2009 ANNUAL LIST OF PROPOSED CHANGES TO MWRA'S EFFLUENT OUTFALL AMBIENT MONITORING PLAN

OCTOBER 23, 2009

Figure 1 Map of proposed water column monitoring stations.

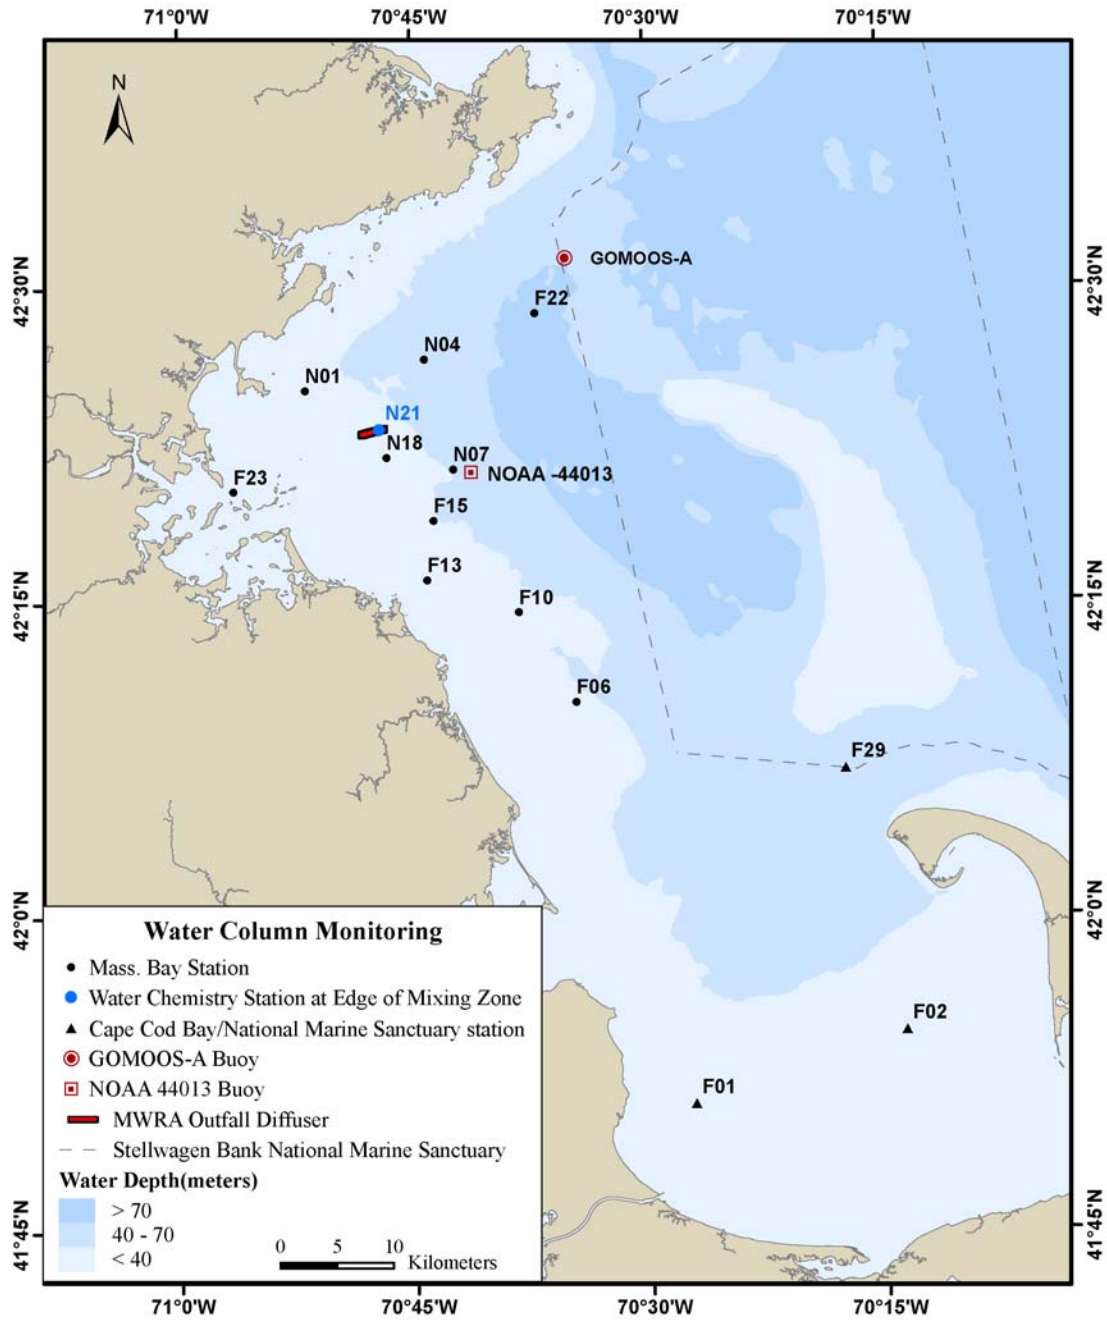
- 2.1 **Reduce the total number of stations sampled from 33 to 14.** This change focuses the monitoring on the geographic area now known to have a possibility of being affected by the discharge. Reference stations are included, but most of the furthest stations are removed.

- 2.1.1 **Delete the following stations: F03, F05, F07, F12, F14, F16, F17, F18, F19, F24, F25, F26, F27, F28, F30, F31, N10, N16, N20.**
 - 2.1.2 **Include the following stations: F06, F10, F13, F15, F22, F23, N01, N04, N07, N18, N21 (Figure 1, Table 1).** Measure dissolved nutrients at nearfield station N21 at the edge of the zone of initial dilution, 60 meters from midline of diffuser line.

- 2.1.3 **Sample three stations in Cape Cod Bay-Stellwagen Bank National Marine Sanctuary: F01, F02, F29 (Figure 1, Table 2).** Parameters will include *in situ* water quality, water column chemistry, and plankton, sampled 9 times annually at two depths. As much as logistically feasible, sample synoptically with outfall monitoring stations.

Figure 2 Proposed nearfield benthic sampling stations.

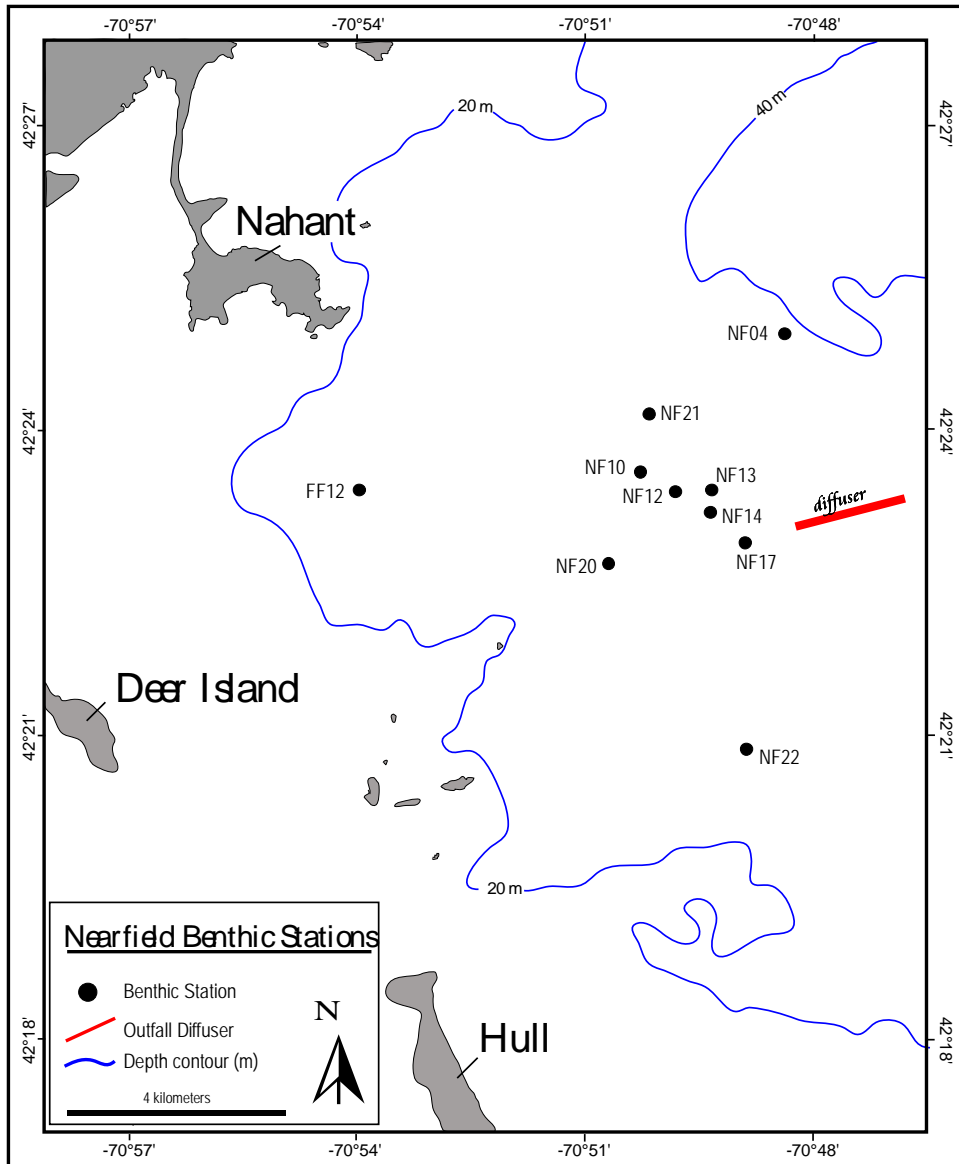
- 3.1 Reduce the benthic community monitoring from the current 31 stations (23 stations in western Massachusetts Bay and eight reference stations more distant from the outfall) to 13 stations (ten nearfield (Figure 2) and three farfield stations (Figure 3)).** In a change from current monitoring, in which half of the stations are sampled in odd years and the other half sampled in even years, all 13 stations will be sampled each survey. (No change to the rapid benthic assessments-sediment profile imaging which will continue at the 23 original nearfield stations.)

- 3.1.1 Delete the following 18 benthic stations: NF02, NF05, NF07, NF08, NF09, NF15, NF16, NF18, NF19, NF23, NF24, FF05, FF06, FF07, FF10, FF11, FF13, FF14.**

- 3.1.2 Community analyses at the following 13 benthic stations: NF04, NF10, NF12, NF13, NF14, NF17, NF20, NF21, NF22, FF12, FF01A, FF04, FF09**
- 3.2 Modify the sampling frequency for the hard bottom study from once per year to every third year, to be sampled the same year as sediment chemistry.**
